Drawing title			
PROPOSED PLANS FIRST AND ROOF / SITE			
North			
Drawn		RW	
Date		SEPTEMBER 2019	
Scale		1:100	
Filename			
Job No	1908	Drawing No	DA03
		Revision	C

Project
KELLEHER RESIDENCE
12 MONTEPIER PLACE
MANLY

Drawing Title
PROPOSED ELEVATIONS

Job No 1908
Drawing No DA04
Revision D

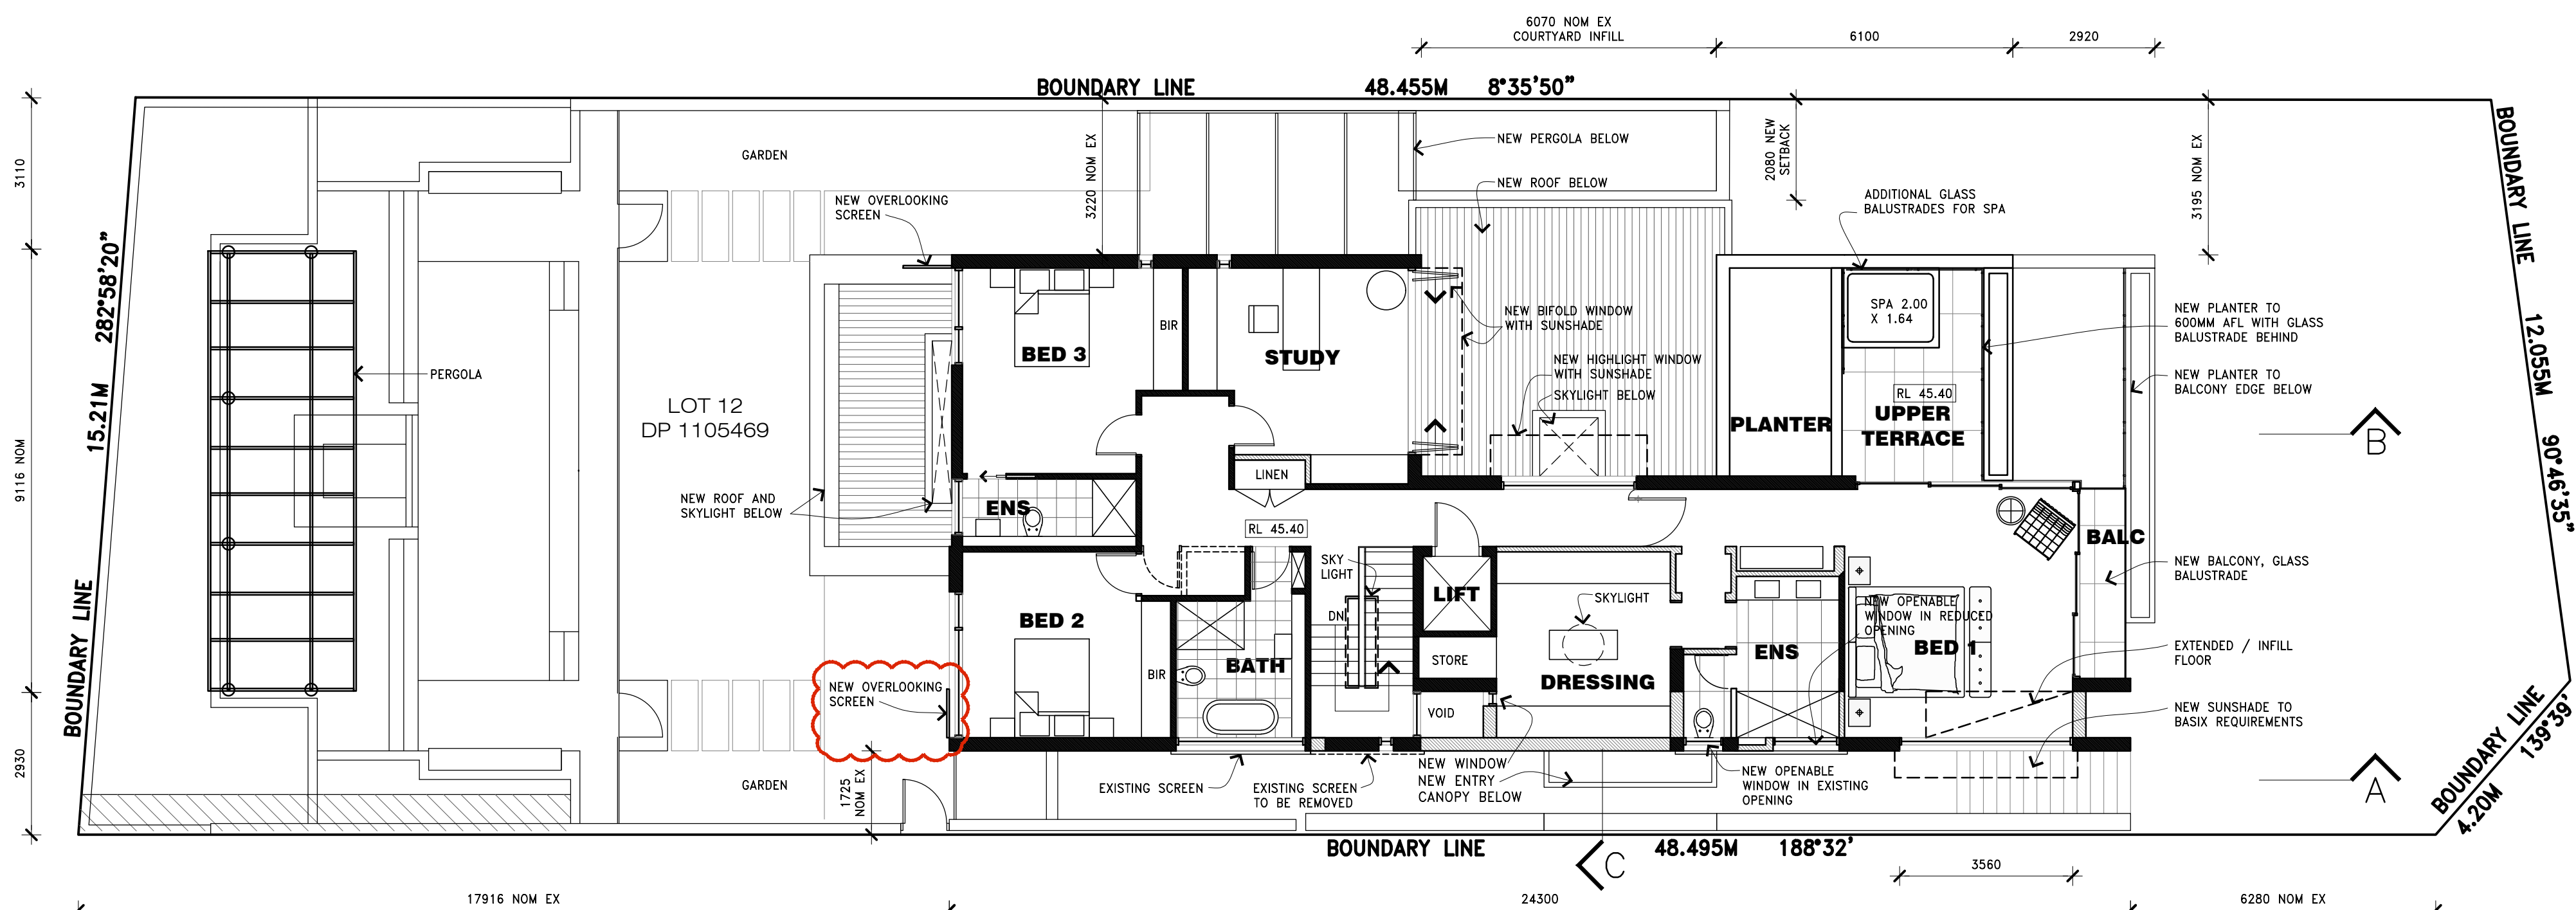
C RW 05/07/22
First floor screen SE corner change to flush with building
B RW 19/10/21 Basement- porches added
Basement- RW tanks relocated
Basement- Store and Service existing walls and doors clarified
Ground-Kitchen walls changed, skylight increased
Ground- coat cpd added to Entry
Ground- masonry fence added to east side Ground- pool retaining walls adjusted
Ground- Games rm door changed to sliding
Upper- spa added to terrace, balustrades added
Upper- Bed 1 window east raised 200mm, operable louvers added, ceiling added
Upper- skylight added to stairwell
Upper- corridor door removed, no linen cpd
Upper- door to Bedroom 2 changed
Upper- South Ensuite still lowered 300mm
Upper- Bed 2 window screen altered
Upper- redundant louvers removed
Roof- new solar system shown
General- new and existing sunshade canopy detail changed to all battens
General- Weirtherex cladding changed to painted Scyon grooved panels
General- boundary fences and retaining walls clarified

General- Woodland Grey finish added

A RW 22/9/20 Planter added to front edge of balconies
Balcony added to front of master bedroom
Window added to east elevation
Window added to west elevation
BBQ relocated adj Breakfast
Loggia / support for first floor S/W corner changed
Fence added around pool terrace
Pool and safety fencing redesign

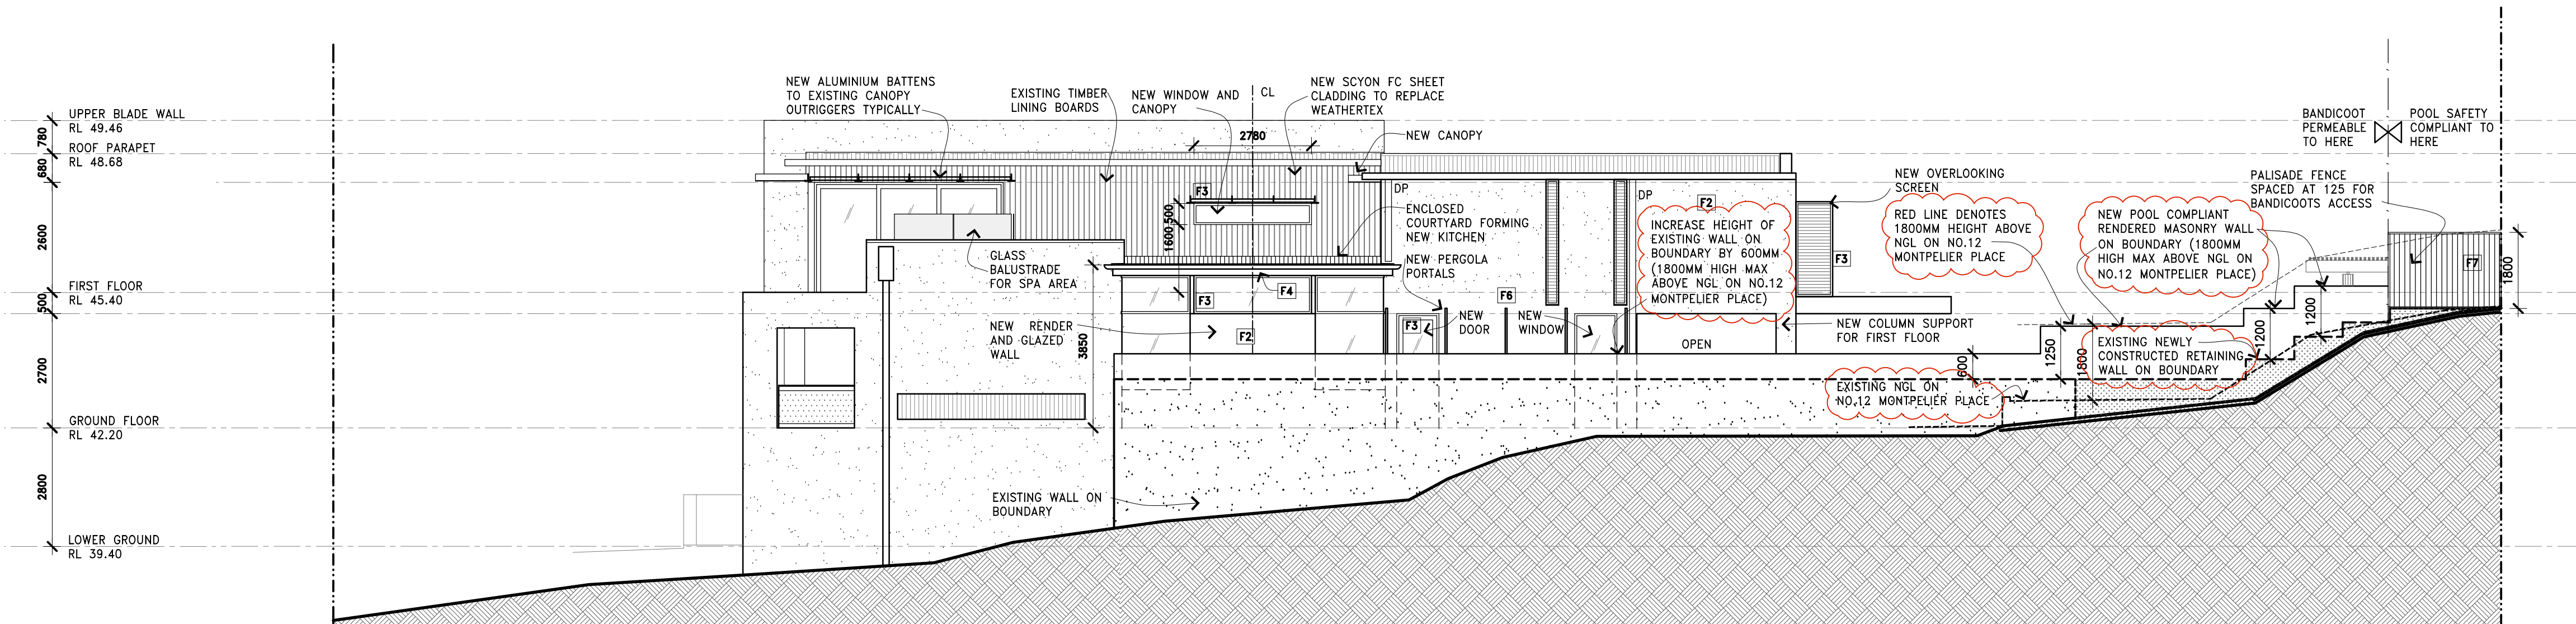
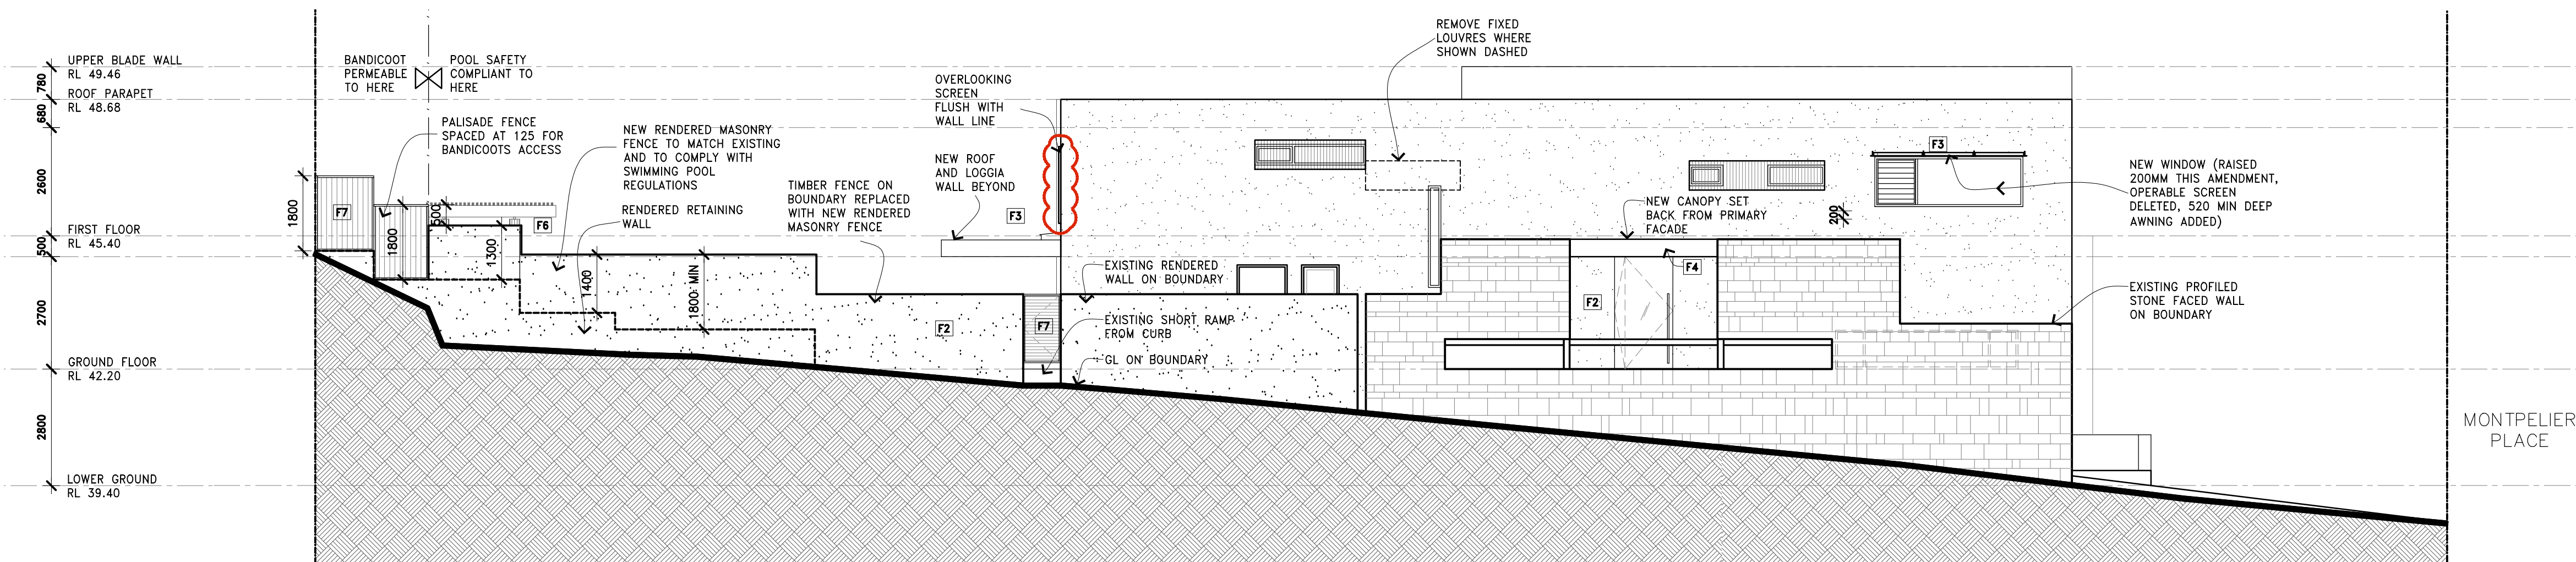
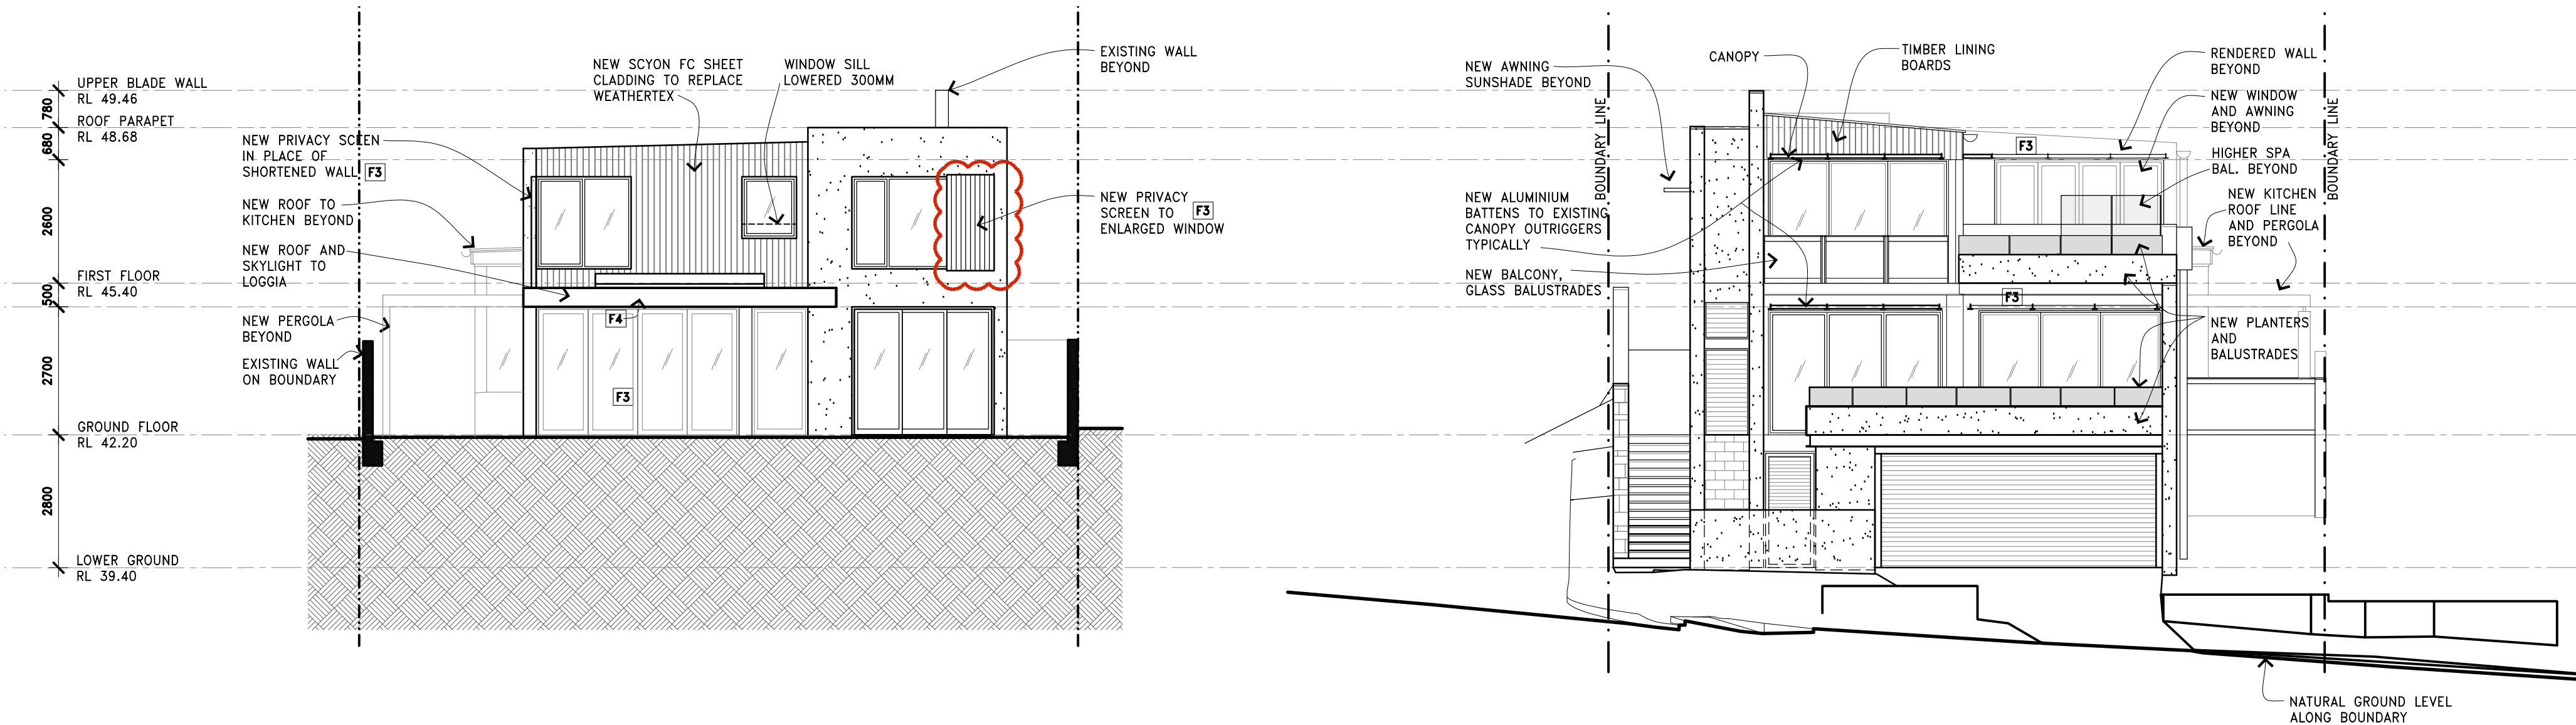
D RW 05/07/22
First floor screen SE corner change to flush with building

C YSY 21/01/22
Existing west boundary fence increased in height by 600mm
(1800 high maximum above NGL on No.12 Montpelier Place)
Pool compliant masonry fence (south-west boundary) not to exceed 1800mm high above NGL on No.12 Montpelier Place

B RW 19/10/21
Basement- porches added
Basement- RW tanks relocated
Basement- Store and Service existing walls and doors clarified
Ground- Kitchen walls changed, skylight increased
Ground- coat cpl added to Entry
Ground- masonry fence added to east side
Ground- pool retaining walls adjusted
Ground- Games rm door changed to sliding
Upper- spa added to terrace, bolustrades added
Upper- Bad 1 window east raised 200mm
Upper- skylight added to stairwell
Upper- corridor duct removed, no linen cpl
Upper- door to Bedroom 2 changed
Upper- South Ensuite still lowered 300mm
Upper- Bad 2 window screen altered
Upper- redundant louvers removed
Roof- new solar system shown
General- new and existing sunshade canopy detail changed to al. battens
General- Weathertex cladding changed to painted Scyon
General- boundary fences and retaining walls clarified
General- Woodland Grey finish added

A RW 22/9/20
Planner added to front edge of balconies
Balcony added to front of master bedroom
Window added to east elevation
Window added to west elevation
BBQ relocated adj Breakfast
Loggia /support for first floor S/W corner changed
Fence added around pool terrace
Pool and safety fencing redesign
